**Re: Updated Sound Barrier Requirements
Block 40/47 – Prima Vista – Phases 1 and 4
Teston Road and Pine Valley Drive
Vaughan, Ontario
VCL File: 116-0467**

This Addendum has been prepared to determine if a continuous 2.5 m high acoustic fence across the west property lines of Lot 116 (Phase 1) and Lots 1 and 2 (Phase 4) will provide sufficient screening to allow the elimination of the acoustic fences along the rear property lines of Lots 114

to 116. The proposed (new) acoustic fence locations are shown on Figure 1.

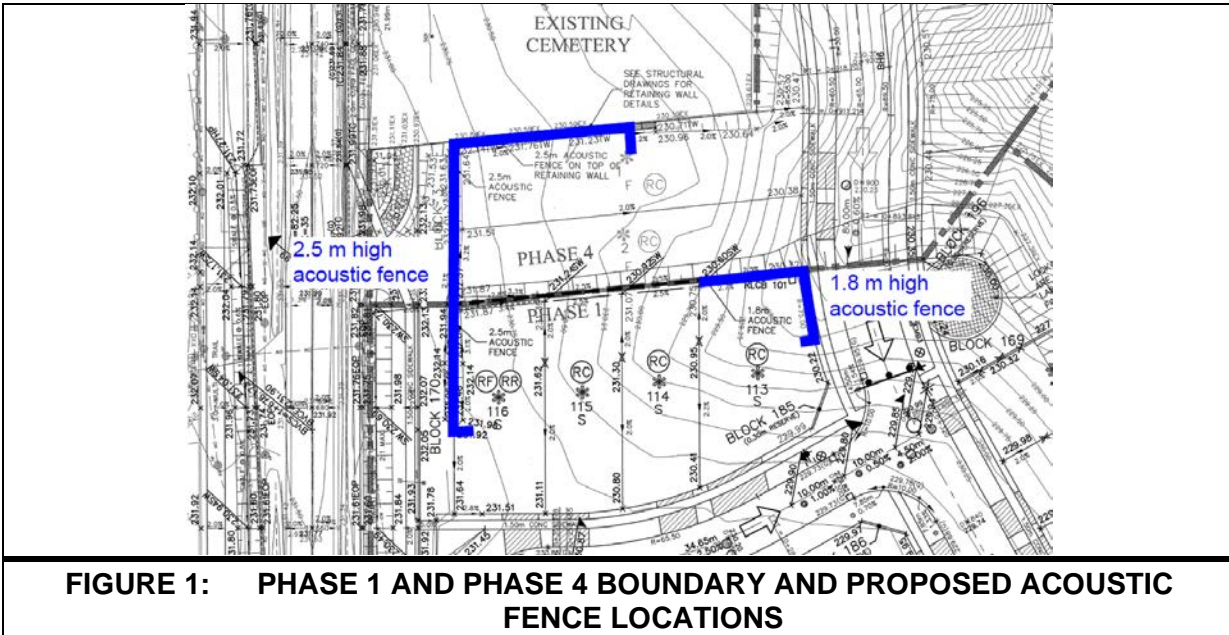
As part of the Noise Report for Phase 1, the following acoustic fences were recommended:

- a 2.5 m high acoustic fence at Lot 116 (siding toward Pine Valley Drive); and
- 1.8 m high acoustic fences at Lots 113 to 115.

As part of the Noise Report for Phase 4, the following acoustic fence was recommended:

- a 2.5 m high acoustic fence along the rear property lines of Lots 1 and 2, with a return toward Lot 1 along the north property line. The acoustic fence was intended to tie-in to the fence at Lot 116 in Phase 1.

With the proposed acoustic fences shown on Figure 1, the mitigated daytime sound levels at Lots 113 to 116 (Phase 1) and Lots 1 and 2 (Phase 2) are between 55 dBA and 60 dBA. This is within the maximum permitted under the MECP guidelines, provided warning clauses are registered on title.

The assessment concludes that the new proposed sound barrier alignment, as shown in Figure 1, will result in compliance with upper allowable daytime sound level limits in the OLAs of Lots 113 to 116 (Phase 1) and Lots 1 and 2 (Phase 4).
